City of San Antonio

Re: **Sonoma Verde (Amended)**

MDP # 835-A

The City Staff Development Review Committee has reviewed **Sonoma Verde Subdivision (MDP) Master Development Plan # 835-A**. Please find enclosed a signed copy for your files. Your plan is accepted however please note the following:

SHEET
C-1.1

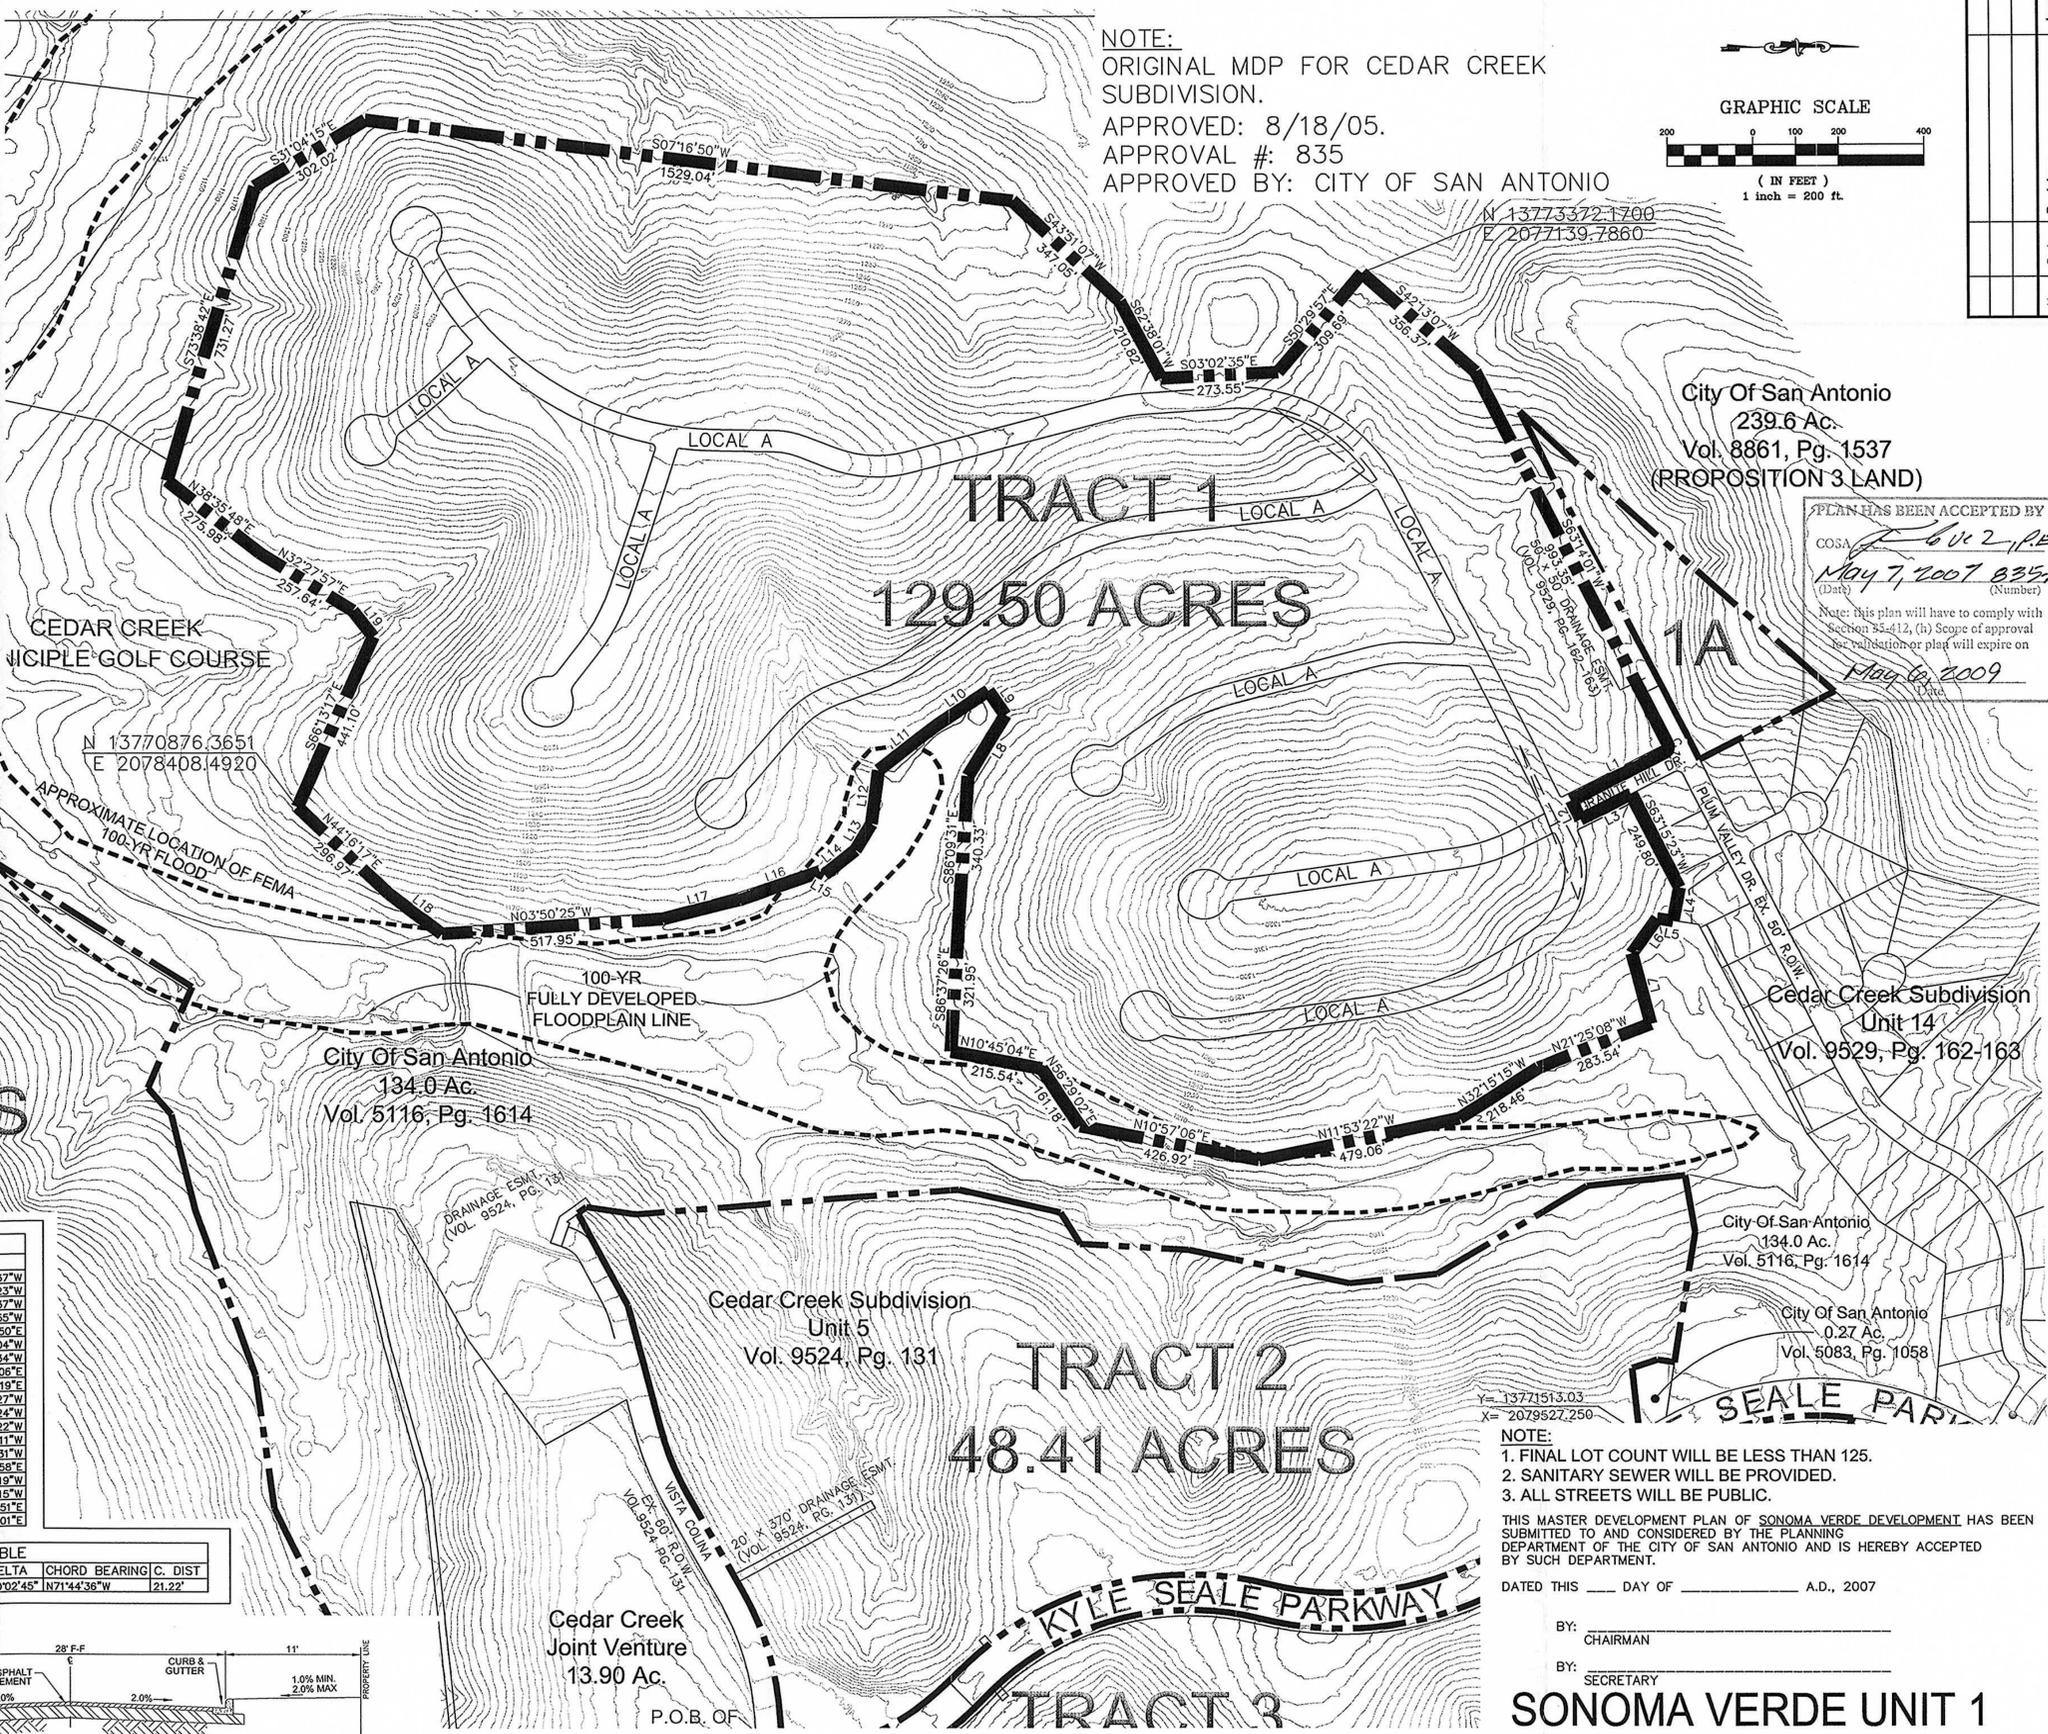
2. ***Kyle Seale Parkway***-The developer shall be responsible for upgrading capacity, which includes left-turn deceleration lanes with a storage lane and bay taper as it relates to the submitted TIA traffic counts, (Unified Development Code (UDC)-35-502(a)(7), subsection C.

3. ***Tract 1 – 129.50 Acres*** – Tract shall consist of 124 lots as indicated in the Development Summary Table. Interior layout of streets and lots shall be reviewed at platting for compliance with UDC 35-506 requirements.

4. Clear sight distances shall be provided at each roadway intersection to allow adequate, obstruction-free viewing distances for approaching traffic. All signage, landscaping and improvements should be selected and located so as to not obscure the minimum intersection visibility.

5. All Roadways shall conform to UDC 35-506 (c), (1), Table 506-1: Functional Classification System Description.
6. All commercial driveways for this project shall comply with UDC 35-506, (r) Access and Driveways.

7. Provide clear sight distance at each roadway to provide adequate distance for obstruction free viewing distances for approaching traffic. All signage, landscaping and improvements should be selected and located so as to not block these clear sight distance areas.

- The following improvements will be provided by the developer prior to completion of the Sonoma Verde Subdivision:
 1. All median modifications of Kyle Seale shall conform to the City of San Antonio standards.
 2. Traffic controls shall be warranted as per the Texas Manual on Uniform Control Devices and approved by TXDOT and / or Bexar County.
 3. It is understood that this MDP is a conceptual plan and all regulations will be addressed at the time of platting. Bexar County reserves the right to address Driveways, Street Design, and Sight Distance, ADA requirements, Drainage and Flood Plain issues at the time of platting.
